**TRACY DEFENSE DEPOT (USARMY)
EPA ID: CA4971520834
OU 01
TRACY, CA
07/31/2001**

Explanation of Significant Differences to the Selected Remedies in the ROD for SWMUs 2, 3, 7, and 33, Building 30 Drum Storage Area, and the Northern Depot Soils Area

FINAL

41-F0602236.00 00353
31 July 2001

Figure 6-5.
Institutional Controls for the Northern Depot Soils Area
Defense Distribution Depot San Joaquin - Tracy

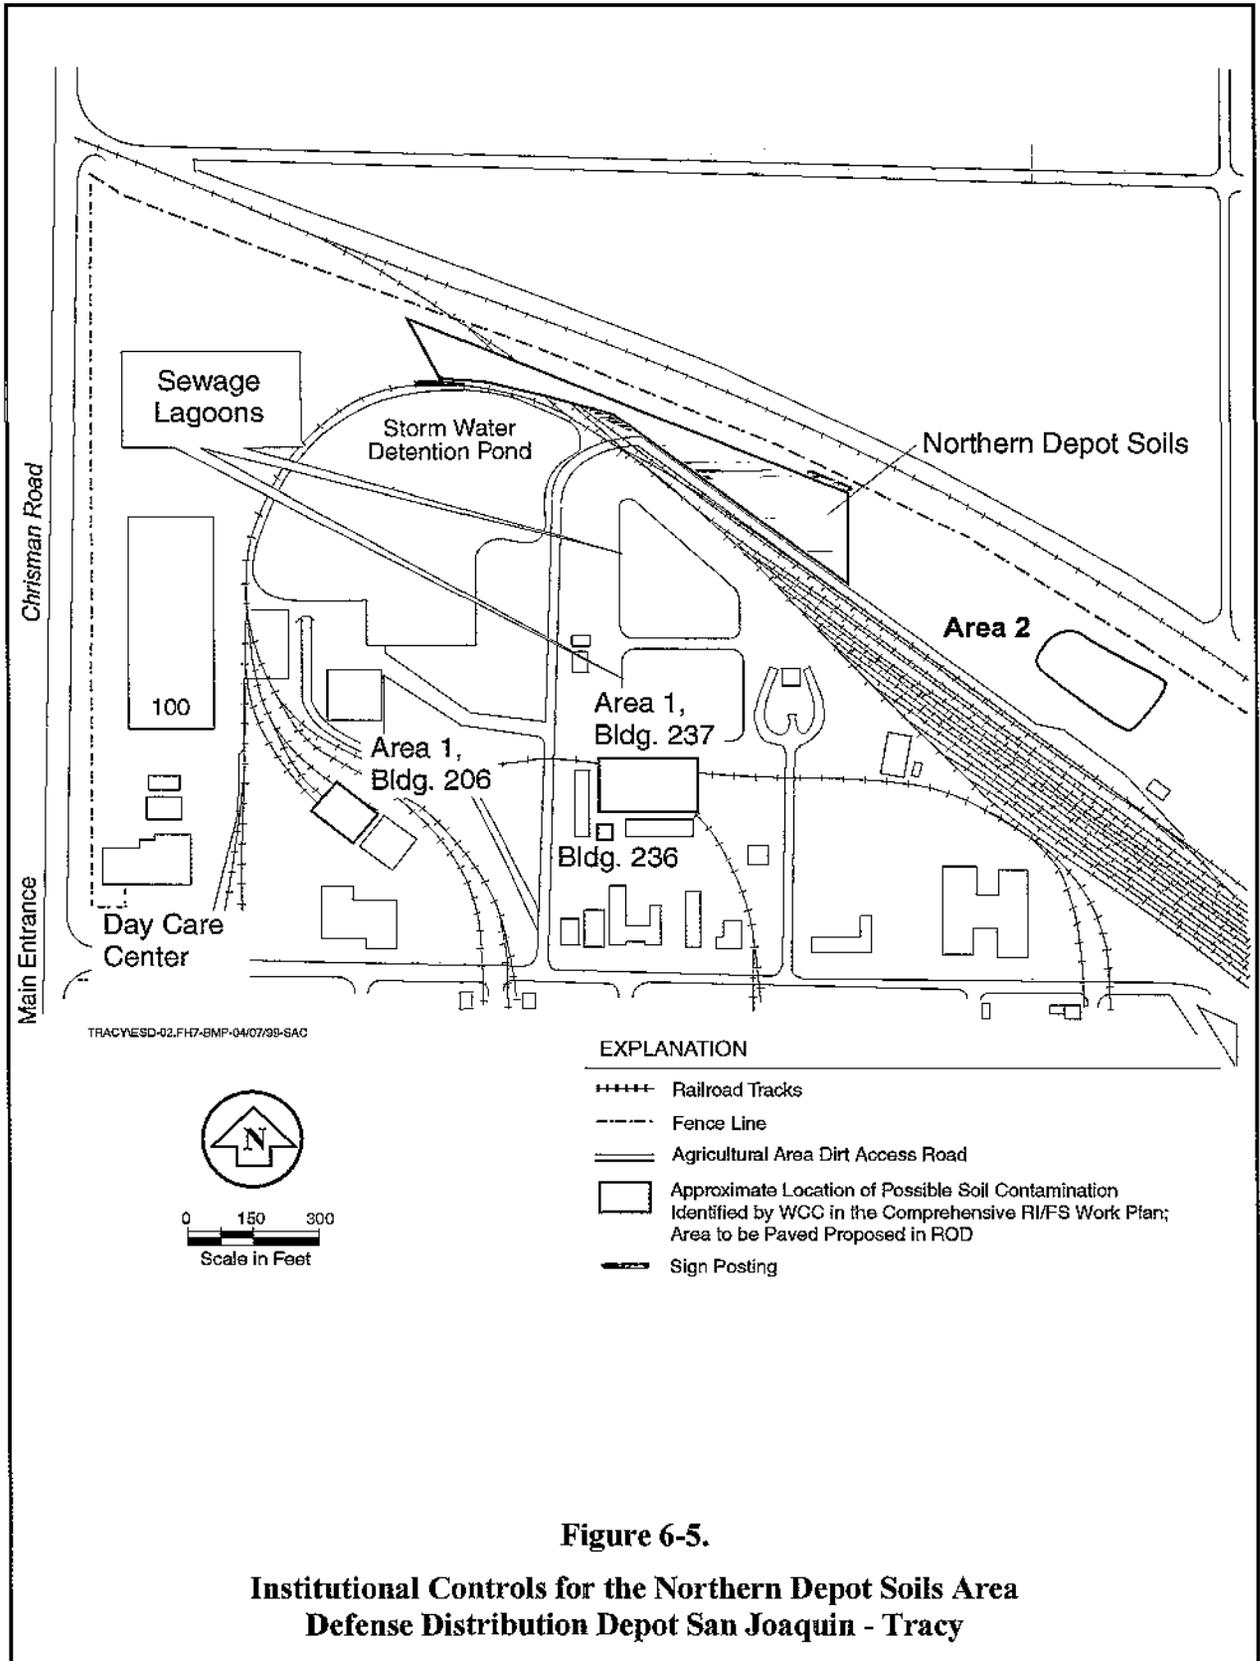
6.6.1 The construction of an asphalt cap is the selected remedy for the Northern Depot Soils Area. Institutional controls will be used to maintain the cap. The Remedial Action Report will detail the installation of the asphalt cap, along with its specific inspection and maintenance requirements. The land use restrictions for the paved areas require that the asphalt cap constructed at the Northern Depot Soils Area be maintained. Removal and/or modification of the pavement constitutes disruption of the selected remedy and triggers notification of the agencies and follow-up activities to ensure that the controls are fully restored. Maintaining the existing pavement prevents the potential exposure of site workers to arsenic and manganese in the surface soil.
